## REVISION TRANSMITTAL SHEET

This sheet transmits Revision 1 to Service Bulletin No. RE220-49-7558.

# RE220-49-7558

AIRBORNE AUXILIARY POWER – GAS TURBINE ENGINE – Remove/Replace EGT Sensor, Part No. WE3876282-1 with Part No. WE3876352-1 and Replace/ Rework Wiring Harness, Part No. WB3888400-1 with/to part No. WE3888471-1.

Wire Harness Installation  
Figure 1

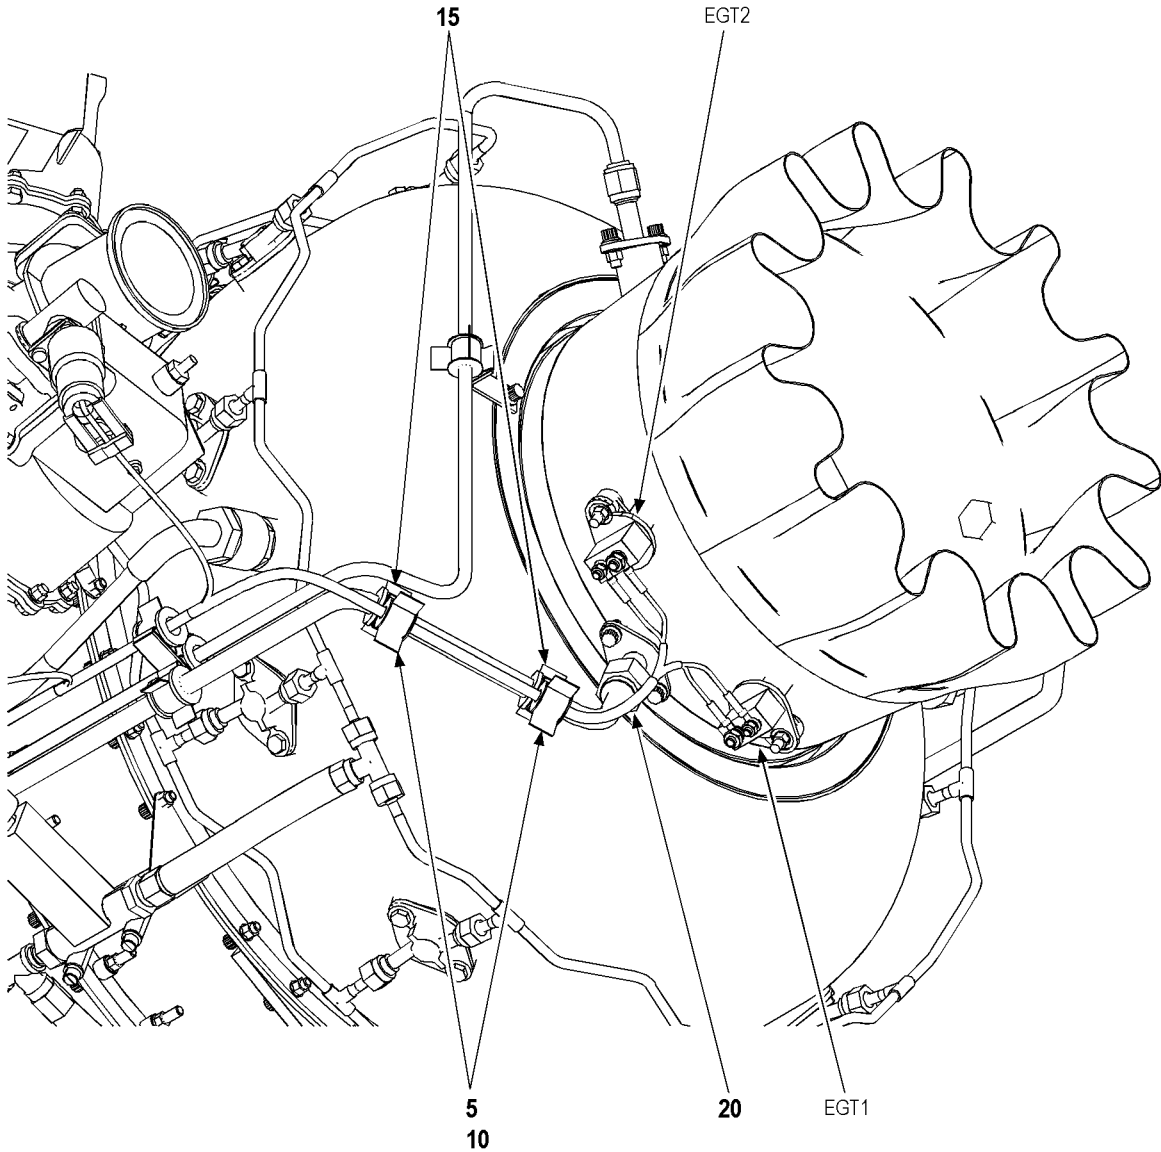
- (1) Remove harness (5, Figure 1) and grommets (10) from clamp (15), two places.
- (2) Identify the EGT wiring connected to Pins A and B of connector plug formerly attached to the dual EGT sensor. Cut those wires 12 in. (304,8 mm) away from dual EGT sensor connector plug. Temporarily mark wiring on APU portion of harness as EGT1.
- (3) Cut the remaining EGT wiring 9 in. (228.6 mm) away from dual EGT Probe connector plug. Temporarily mark this wiring as EGT 2.

Wire Harness Modification  
Figure 2

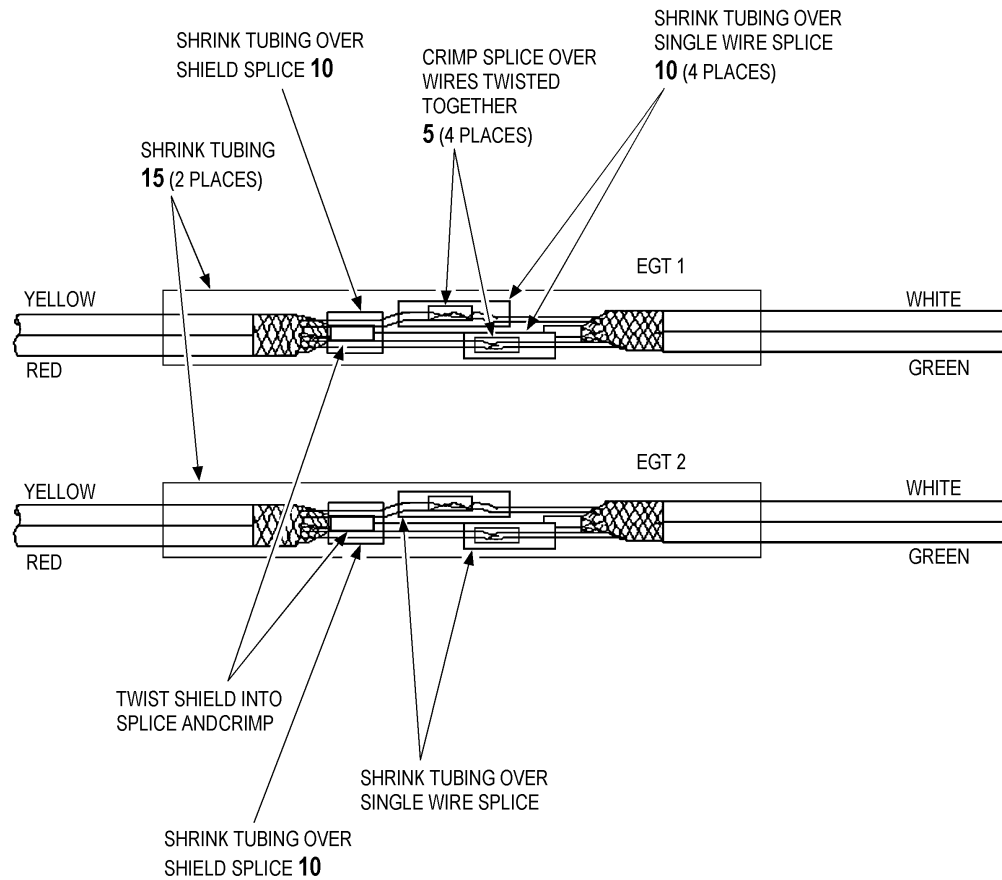
- (4) Discard removed wiring and connector plug.
- (5) Loosely install terminals of harness adapter (20, Figure 2) to EGT sensor studs. Terminals for EGT1 should be connected to the sensor located at the six o'clock position, and terminals for EGT2 should be connected to the sensor located at the eight o'clock position.
- (6) Add two grommets (15) to the turbine bearing scavenge line in the locations shown in Figure 2. Ensure that the split in the grommet is facing aft. Apply tape (pressure sensitive polytetrafluoroethylene tape per ASTM-D-2686, Permacel No. 423 Teflon Tape, manufactured by Permacel Industrial Tape Products, New Brunswick, NJ, or equivalent) around the grommet (15). Attach clamp (10) to each grommet (15).

- (7) Attach two grommets (5) to harness adapter (20) and route to existing APU wiring. Position grommets and wiring into clamps (10). Adjust the wiring and clamps so that there is sufficient length to reduce stress yet not risk chaffing during vibration.
- (8) On adapter harness, identify the wiring from the EGT1 probe and trim the length to allow splicing to the APU harness in the configuration (Staggered Splices) shown in Figure 5. Three splices per wire pair. Re-trim APU harness as needed to accommodate the staggered splices.
- (9) On adapter harness, identify the wiring from the EGT2 probe and trim the length to allow splicing to the APU harness in the configuration (staggered splices) shown in Figure 5. Three splices per wire pair. Re-trim APU harness as needed to accommodate the staggered splices.

- (17) Install grommets (5, Figure 2) onto EGT wiring ensuring that the split is facing towards the APU. Apply tape (pressure sensitive polytetrafluoroethylene tape per ASTM-D-2686, Permacel No. 423 Teflon Tape, manufactured by Permacel Industrial Tape Products, New Brunswick, NJ, or equivalent) to the grommets(5) and position the grommet (5) into the clamps (10). Make sure that the grommet is positioned within the clamp so that the grommet split is within the clamp radius.

Wire Splices Installation  
Figure 3

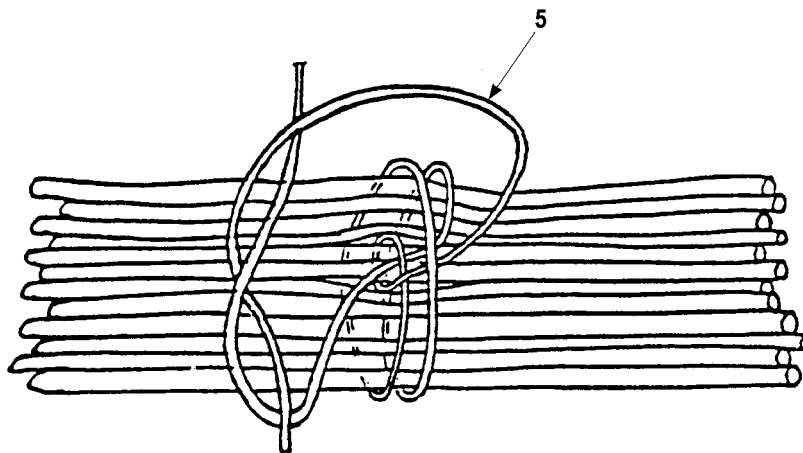
Page 5. Changed tape in step D.(6).  
Page 7. Changed Harness Adapter part number.  
Page 8. Removed "(red)" from paragraph D.(12)(e).  
Page 9. Changed Figure 3 and updated insulation part number.  
Page 12. Changed tape in step D.(17).

- (a) Trim six, 0.75 in. (19,05 mm) pieces from insulation sleeve (10).
  - (b) Trim two, 6 in. (152,4 mm) pieces from insulation sleeve (15).
  - (c) Route each wiring pair, Alumel and Chromel, through insulation sleeve (15).

- (d) Route each individual wire, Alumel and Chromel, and shield through insulation sleeve (10).
  - (e) Route the un-crimped splice (5) through one wire. Twist two wire sections (section includes harness adapter and harness) together, ensure wires are properly joined, i.e., Alumel to Alumel, etc. Slide the splice over the twisted wiring and crimp the splice (5). This will need to be accomplished for each wire, a total of four splices. (Refer to Figure 3.)

- (f) Route the un-crimped splice (5) through the wire shielding. Twist the section of shielding together. Slide the splice (5) over the twisted shielding and crimp the splice (5). Total number of splices needed for the shielding is two. (Refer to Figure 3.)

- (g) Position the insulation sleeve over each splice assembly and shrink the insulation sleeve (10) over the splices (5) using a heat gun. (Refer to Figure 3.)

- (h) Position the insulation sleeve over the spliced connections and shrink the insulation sleeve (15) over the wiring pair and spliced connections using a heat gun. (Refer to Figure 3.)

Wire Bundle Tying  
Figure 4

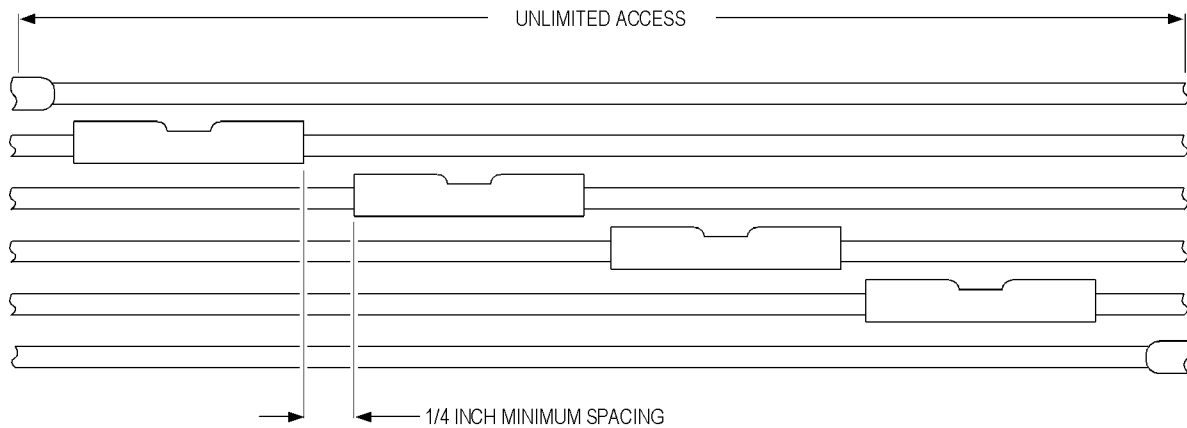
- (13) Lace braid (5, Figure 4), 1 to 2 in. (25,4 to 50,8 mm) apart to limit the movement of the individual EGT wires.
- (14) Trim the loose ends of the braid (5) so that the cut ends of the cord extend approximately 3/8 in. (9,525 mm) from the knot.

**NOTE:** Make sure all reworked areas have a braid tie (5) approximately 1 to 2 in. (25,4 to 50,8 mm) apart.
- (15) Secure the knot and ends, apply sealing compound (PCS5752 Type II, product of HumiSeal, Woodside, NY 13777, or equivalent).
